Our Ref. : DD118 Lot 1937 & 1938  
Your Ref. : TPB/A/YL-TT/737

**2<sup>nd</sup> Further Information**

**Proposed Temporary Warehouse (Excluding Dangerous Goods Godown) with Ancillary Facilities  
and Associated Filling of Land for a Period of 3 Years in "Agriculture" Zone,  
Lots 1937 (Part) and 1938 in D.D. 118, Tai Tong, Yuen Long, New Territories**

**(S.16 Planning Application No. A/YL-TT/737)**

DWG NO. PLAN 4	VER. 001
-------------------	-------------

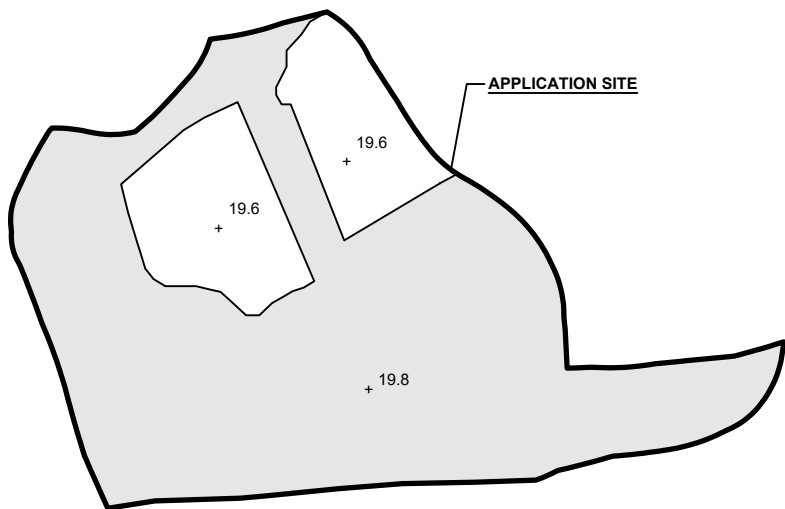
(1)	The local track road, which accommodating 2-way traffic leading to the Site is not under TD’s purview. Since the Site will be accessed by container vehicles, the applicant should provide a swept path analysis along	The applicant has revised the L/UL spaces provision from 1 L/UL space for CVs, to 2 L/UL spaces for LGVs. The applicant believed that using LGVs for transportation of goods could provide better circulation

- (i) The applicant has updated the layout of the application site (the Site): instead of providing one loading/unloading (L/UL) space for container vehicles (CVs), 2 L/UL spaces for light goods vehicles (LGVs) will be provided within the Site (**Appendix IV**). Such arrangement is for better circulation purposes within the Site; better accesses for the Site to/from Tai Shu Ha Road East via the local track road; as well as to lessen any potential impacts arising from the proposed development to the surrounding areas. As the applicant proposed to plant new trees to compensate for existing felled trees, two portions of the Site would be excluded from the land filling activity which is shown at **Appendix V**. This is to provide adequate spaces for growth of the new trees and to mitigate any adverse impacts made to the trees from the proposed development. Revised pages of the application form and the planning statement is enclosed at **Appendices II and III**; and

the local track road for further comment.	within the Site; better accesses for the Site to/from Tai Shu Ha Road East via the local track road; as well as to effectively lessen any potential impacts arising from the proposed development to the surrounding areas ( <b>Appendix IV</b> ). Considering the size of assessing vehicle types (private cars and LGVs), the previous swept path analysis would be applicable.
<b>Comments of the Chief Town Planner/Urban Design and Landscape Section, Planning Department (CTP/UD&amp;L, PlanD)</b> <b>Contact Person: Ms. CHAN, Tel.: 3565 3949)</b>

DWG NO. PLAN 5	VER. 001
-------------------	-------------

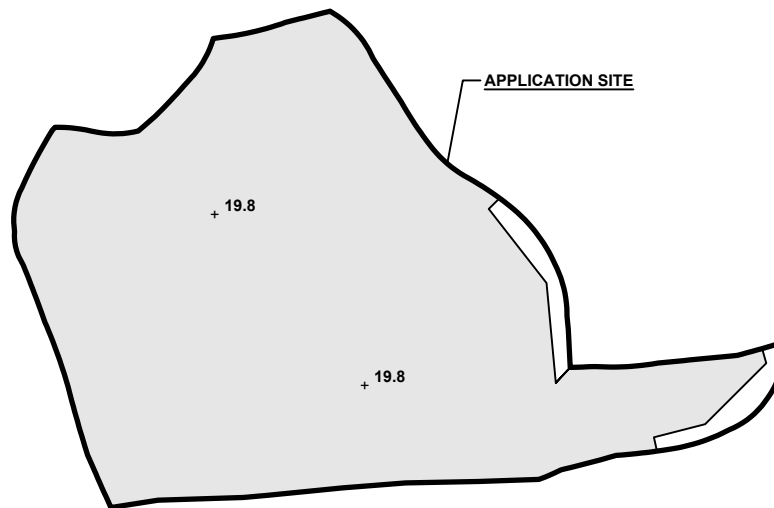
(1)	It is noted that the Site is partly paved and partly vegetated. Please update the filling of land plan accordingly to reflect the existing site condition.	Noted. The updated land filling plan is enclosed at <b>Appendix V</b> .

3.2 A portion of the Site (about 2,040 m<sup>2</sup>, 97% of the Site area) is proposed to be filled with concrete of not more than 0.2 m in depth, from the existing level of +19.6 mPD (about) to a proposed level of +19.8 mPD (about) (**Plan 5**). The filling of land is to facilitate a flat surface for site formation of structures and circulation area uses. Such land filling is considered necessary and has been kept to minimal to meet the operational needs of the proposed development. No further filling of land will be carried out by the applicant during the planning approval period.

DWG NO. TSP01	VER. 0
------------------	-----------

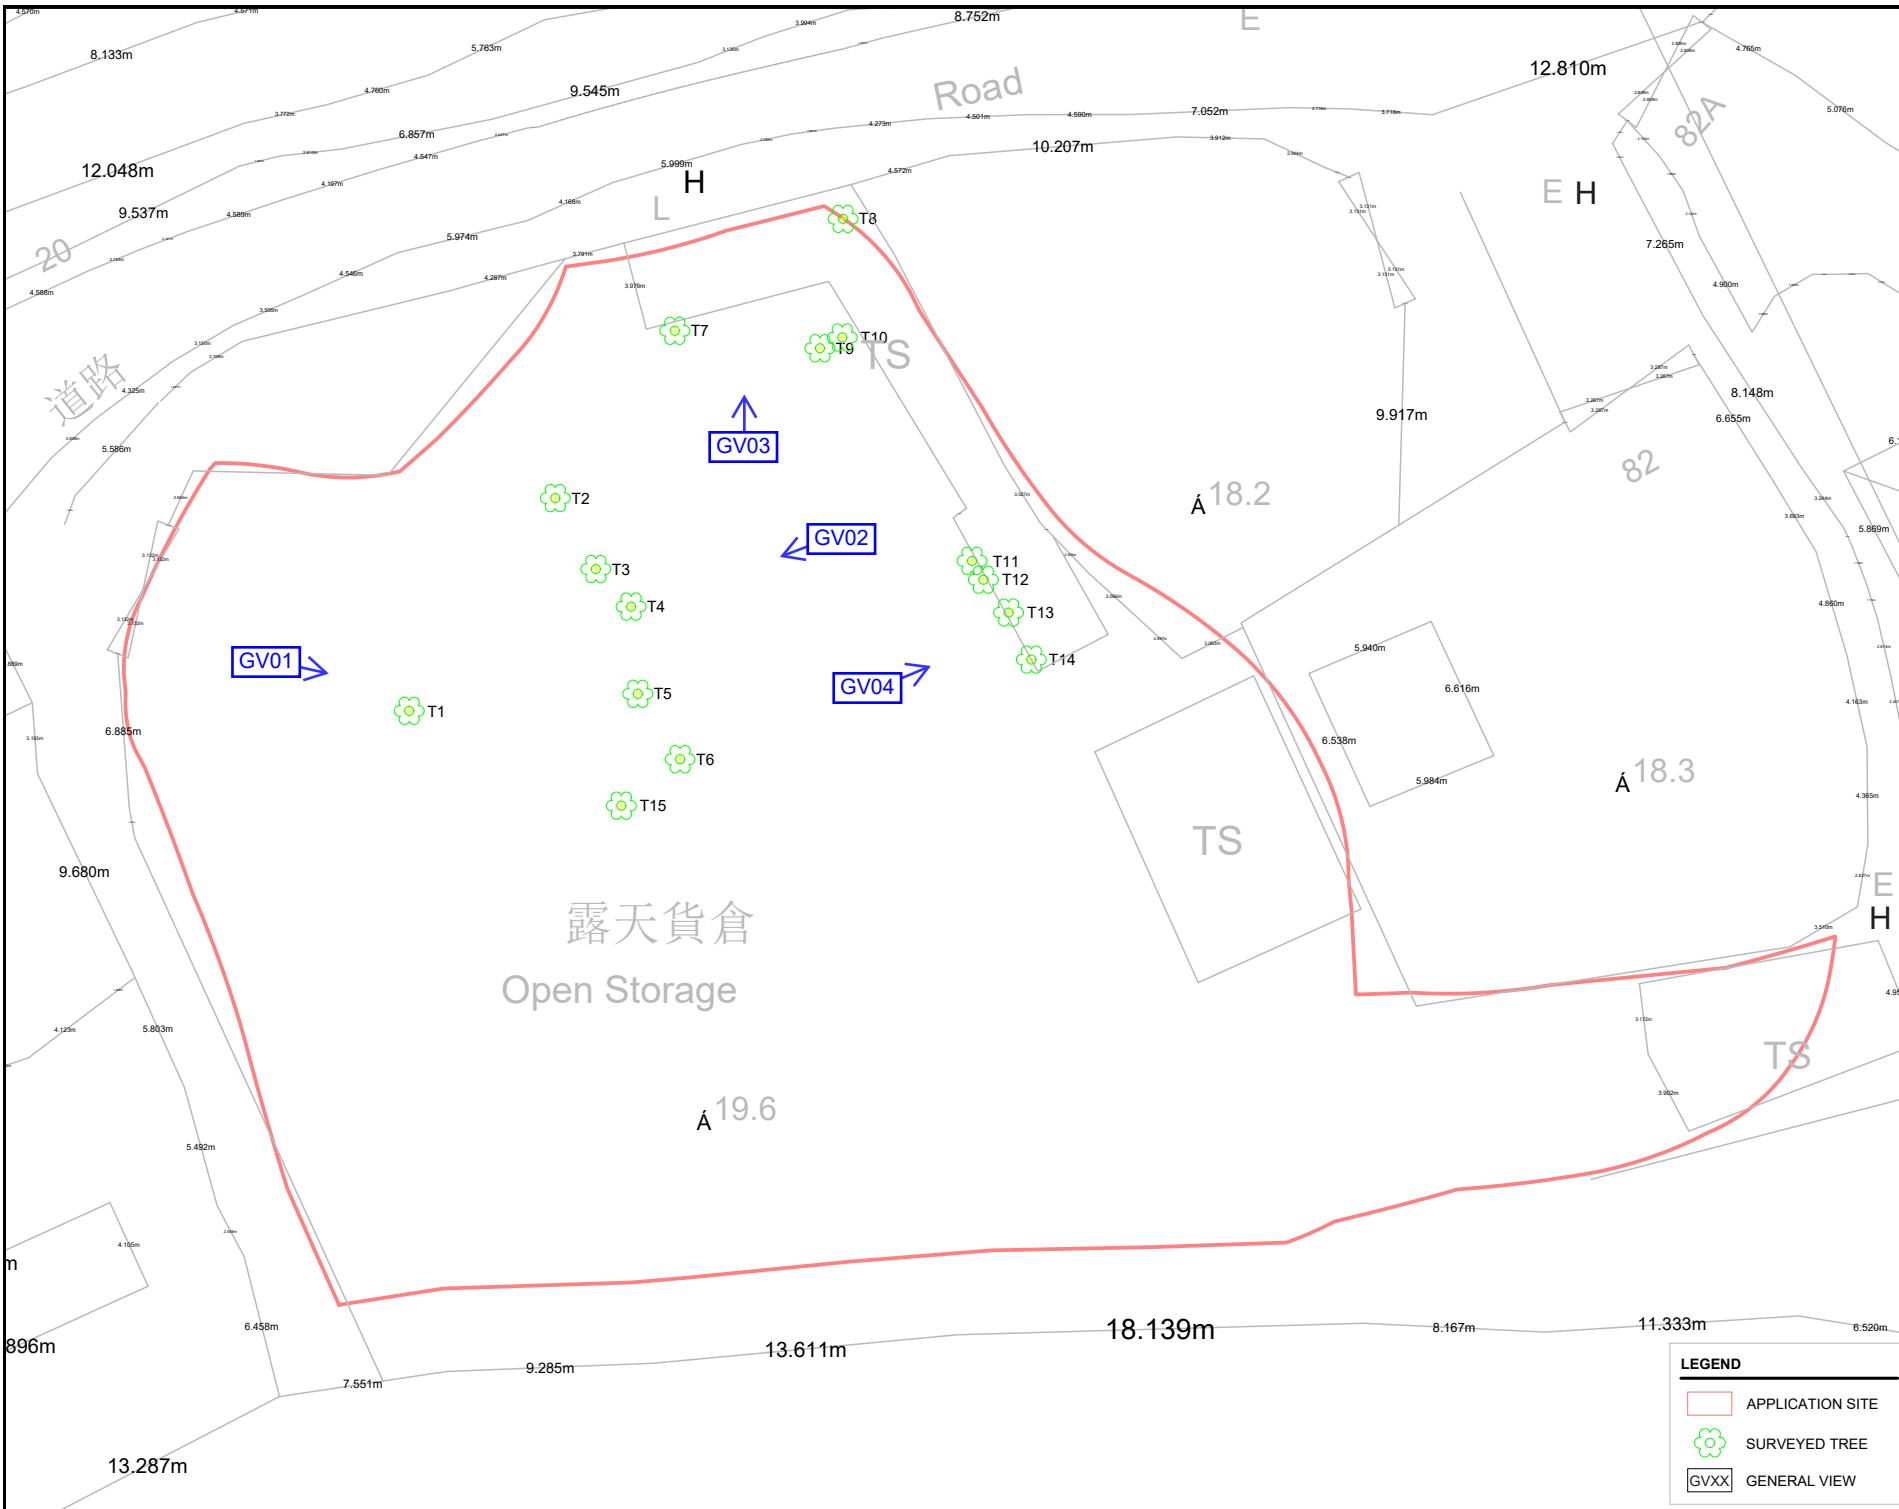
(2)	In the submission, no information on existing trees within the Site is provided. The applicant should provide a broad-brush tree survey with information on existing tree nos., location, tree species and conservation status for review. Since the Site is located adjacent to "Conservation Area", the applicant should also provide a landscape proposal with mitigation measures to demonstrate that the applied uses would not have adverse landscape impact on the Site and the surrounding areas.	A landscape proposal is provided by the applicant ( <b>Appendix VII</b> ) where 15 new trees (i.e. Bauhinia Blakeana) (T1 to T15) are proposed to be planted at the southeastern portion of the Site as a landscape buffer. The proposed 15 new trees will be planted at least 1.2m soil depth for better tree health.

(1)	Existing trees were observed within the Site.	According to the tree survey report conducted on 02.03.2026, 15 nos. of trees were identified within the site boundary ( <b>Appendix VI</b> ). No OVT or protected species has been identified in accordance with the DEVB TC(W) No. 5/2020 - Registration and Preservation of Old and Valuable Trees and the Forests and Countryside Ordinance (Cap.96) respectively. All identified trees are proposed to be felled.

DWG NO.	VER.
PLAN 7	001

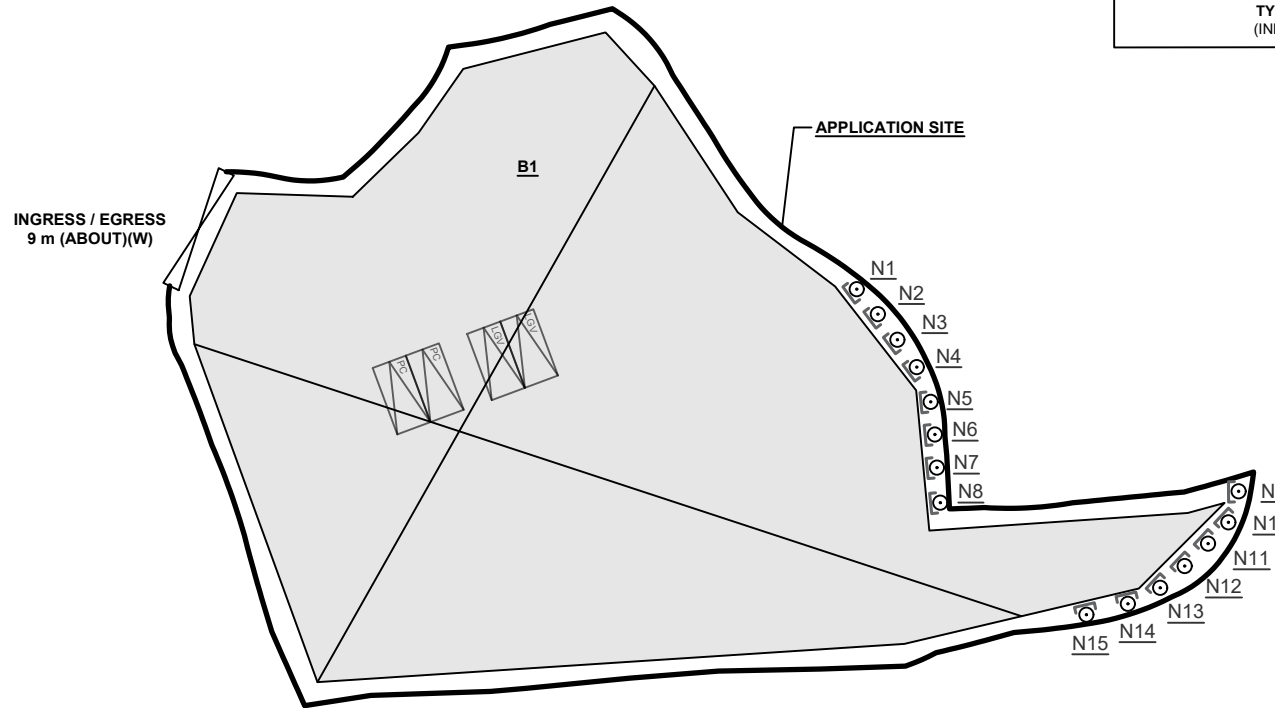
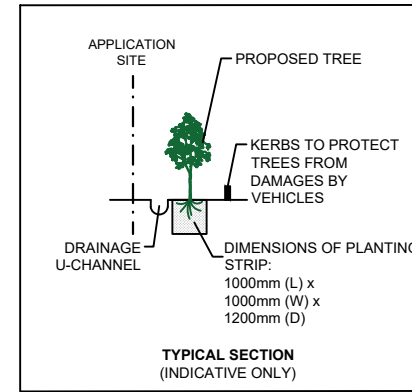
(2)	As the Site is adjacent to “CA”, please submit a landscape proposal to mitigate the potential landscape impacts.	Noted. The applicant has conducted a tree survey within the Site ( <b>Appendix VI</b> ); and to mitigate any potential impacts arising from the Site, a landscape proposal for the Site is also enclosed at <b>Appendix VII</b> .
<b>Comments of the Commissioner of Transport (C for T)</b> <b>(Contact Person: Mr. IP, Tel.: 2399 2565)</b>

(3)	We would reserve our comment upon receipt of the required landscape technical information in accordance with "Guidance notes on the application for permission under Section 16 of the Town Planning Ordinance (Cap. 131).	The new proposed trees are for mitigating any potential visual and landscape impact (if any) towards nearby sensitive receivers. The new trees planted within the Site will be maintained by the applicant in good condition during the planning approval period.
